SERVICE BULLETIN

Service Bulletin No.: DAC1-11-01 Rev 1

Title: Chinese Placards and Markings

1. **ATA Code:** 1120, 1130
2. **Effectivity:** All DA20-C1 Aircraft for operation under Chinese registry.
3. **General:** This Service Bulletin introduces the Chinese Placards and Markings and describes modifications required for aircraft operating under Chinese registry. Revision 1 of this Service Bulletin changes the compliance.
4. **Compliance:** For newly manufactured aircraft, prior to operation of the aircraft in China under Chinese registry; or within the next 100 hours of operation for aircraft already exported to China.
5. **Approval:** Engineering data referenced or contained in this Service Bulletin is approved as part of the type design.
6. **Labour:** Approximately 1 hour will be required to accomplish this Service Bulletin.

Figure 1 (Sheet 1) - Aircraft Placards

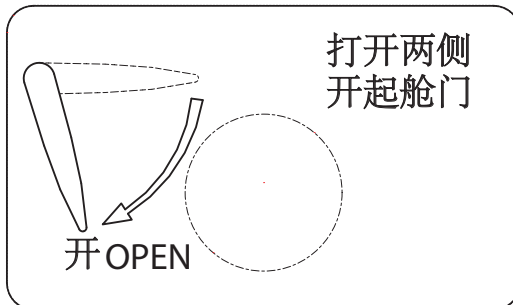
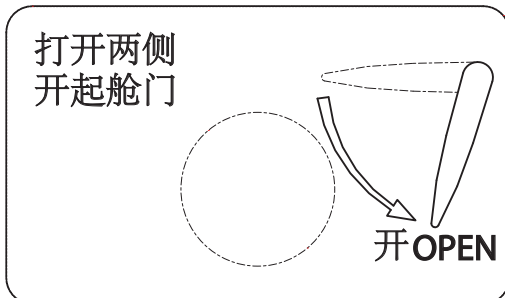
10.1 Replace the English language placards with the Chinese language placards as shown in Figures 1 and 2.

10.2 Replace the canopy lock position placard (P/N 22-1120-05-01).

10.3 Replace the exterior canopy latching placards (P/Ns 22-1120-05-19 and 22-1120-05-20)

10.2.1 Use a hot air blower and plastic spatula to carefully loosen the canopy lock placard from the fuselage skin, then remove the placard.

10.2.4 Remove the protective backing, then align and install the new placard.

10.3.2 Use a hot air blower and plastic spatula to carefully loosen the canopy latching placard from the fuselage skin, then remove the placard.

10.3.5 Remove the protective backing, then align and install the new placard.

Figure 1 (Sheet 2) - Aircraft Placards

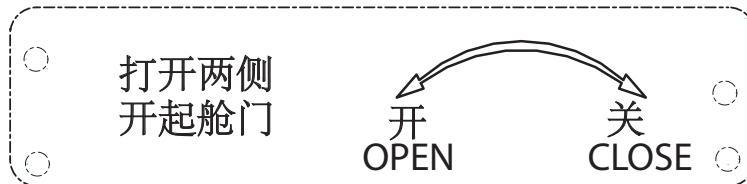
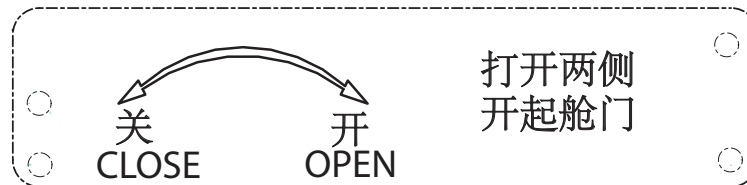
- 10.3.6 Apply an aerodynamic seal around the placard.
- 10.3.7 Install the canopy latching handle.
- 10.4 Replace the interior canopy latching placards (P/Ns 22-1120-05-31 and 22-1120-05-32)

- 10.4.1 Remove the four screws holding the placard to the aircraft.
 - 10.4.2 Use a hot air blower and plastic spatula to carefully loosen the placard, then remove the placard.

- 10.4.3 Clean the surface where the new placard will go with a commercial solvent.
 - 10.4.4 Remove the protective backing, then align and install the new placard.

- 10.4.5 Install the four screws.
- 10.5 Replace the plastic foil placards.
 - 10.5.1 Refer to Figures 1 and 2 to identify the plastic foil placards and the location of each placard.
